Niles Technical Bulletin

To: All Niles Dealers and Representatives
From: The Technical Support Department
Date: 11/17/05
Re: Niles ZR-4630 Feature Update

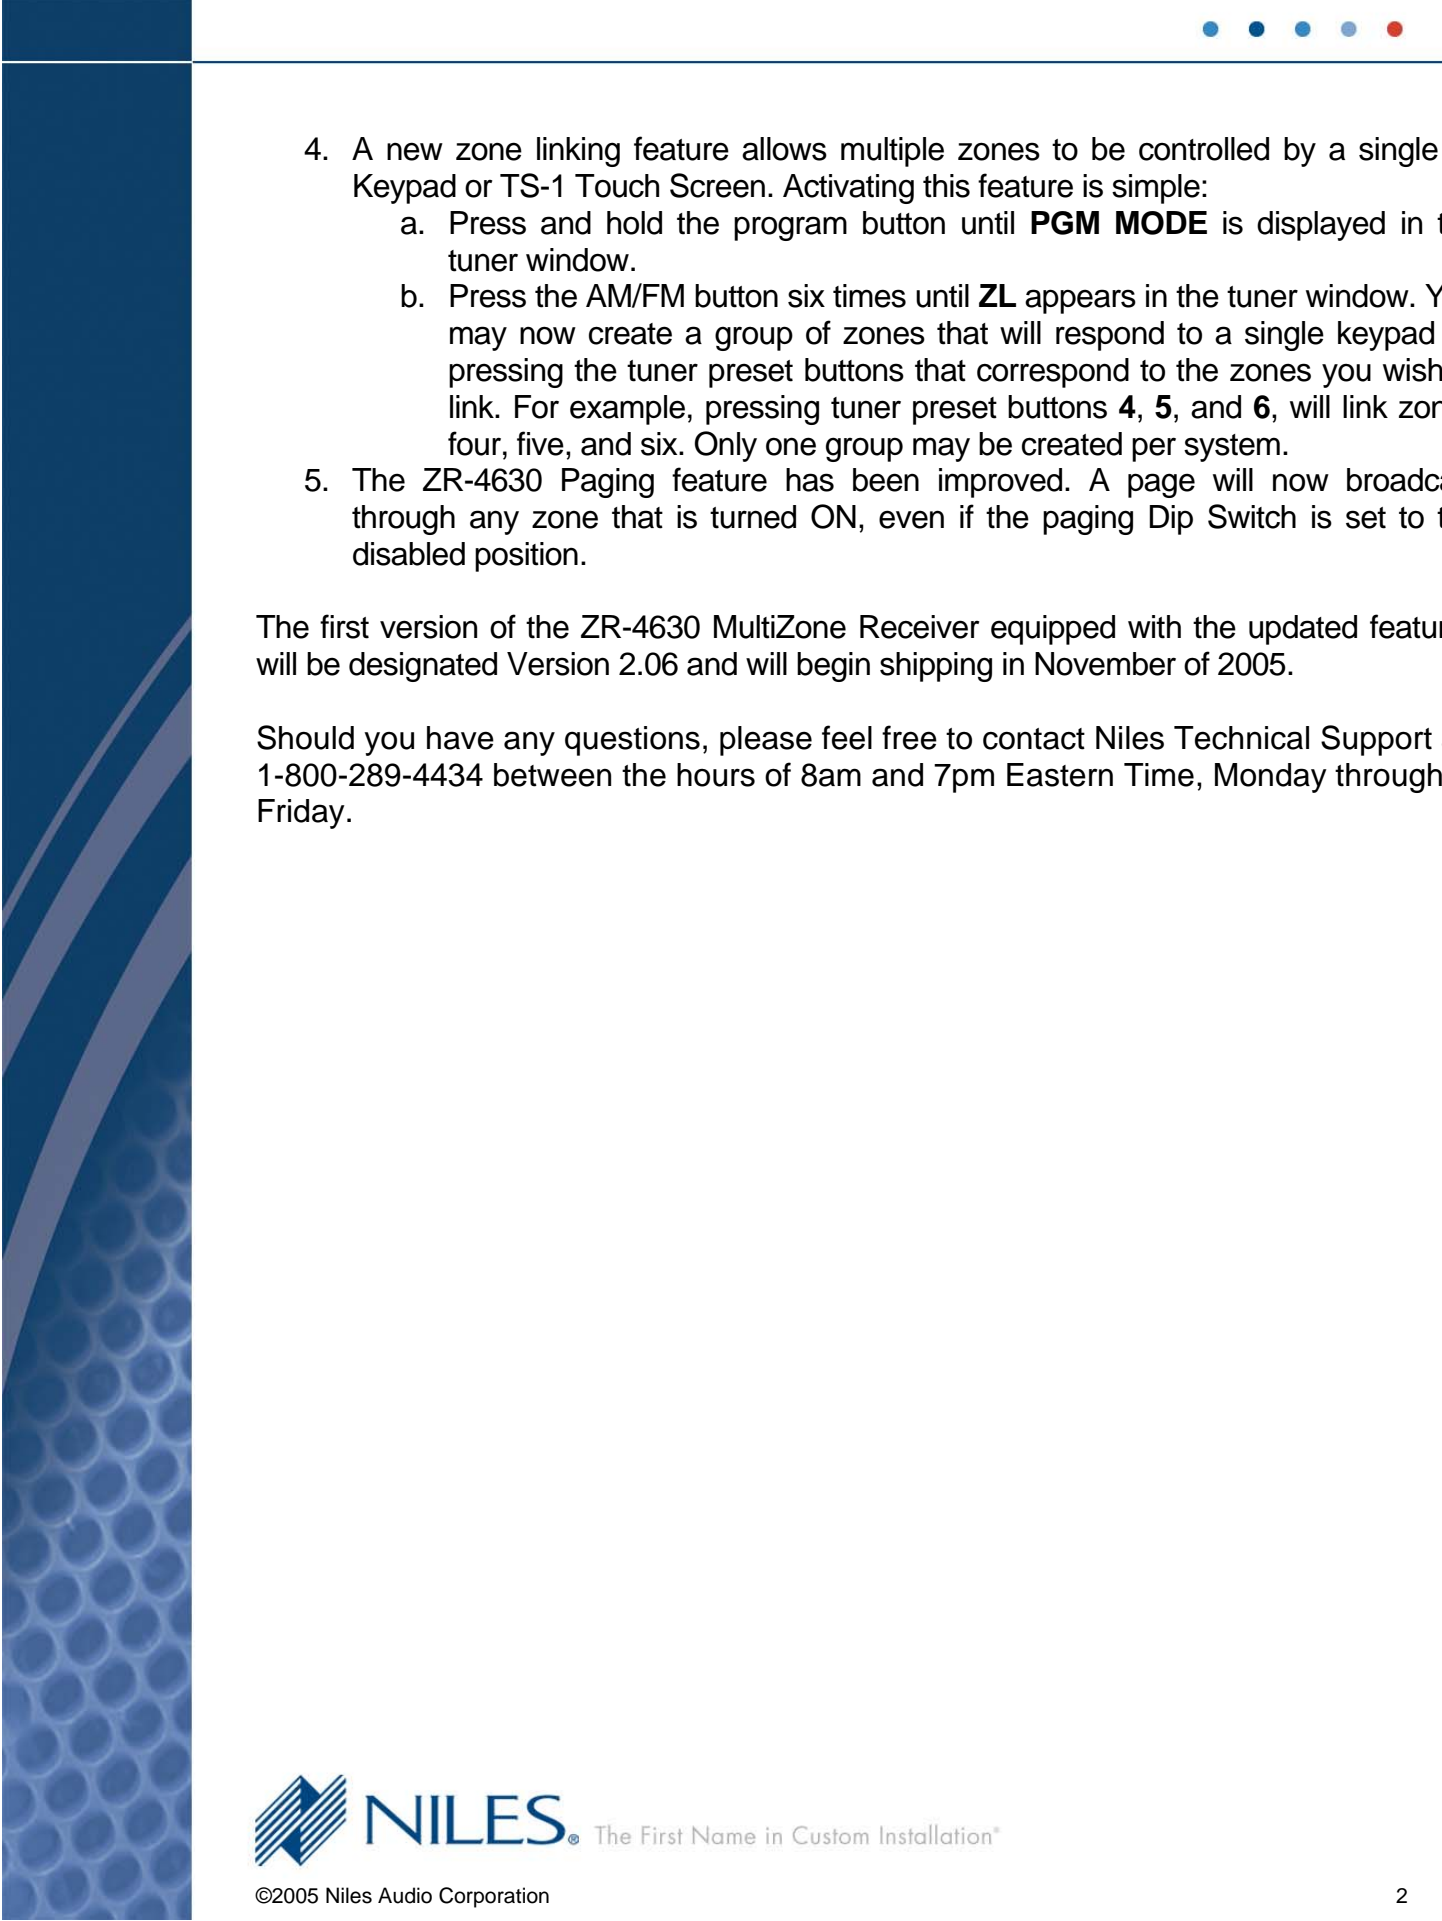
In response to requests from Niles dealers, the ZR-4630 MultiZone Receiver (FG00813) has been equipped with several new features. The updated features are:

1. An improved AM/FM Tuner provides superior performance.
2. A 75-ohm coaxial antenna connector replaces the spring-loaded 300-ohm dipole FM antenna terminals.

3. Gold-plated 5-Way binding posts replace the No-Strip type speaker wire connectors.

- 
4. A new zone linking feature allows multiple zones to be controlled by a single Ci Keypad or TS-1 Touch Screen. Activating this feature is simple:
 - a. Press and hold the program button until **PGM MODE** is displayed in the tuner window.
 - b. Press the AM/FM button six times until **ZL** appears in the tuner window. You may now create a group of zones that will respond to a single keypad by pressing the tuner preset buttons that correspond to the zones you wish to link. For example, pressing tuner preset buttons **4**, **5**, and **6**, will link zones four, five, and six. Only one group may be created per system.
 5. The ZR-4630 Paging feature has been improved. A page will now broadcast through any zone that is turned ON, even if the paging Dip Switch is set to the disabled position.

The first version of the ZR-4630 MultiZone Receiver equipped with the updated features will be designated Version 2.06 and will begin shipping in November of 2005.
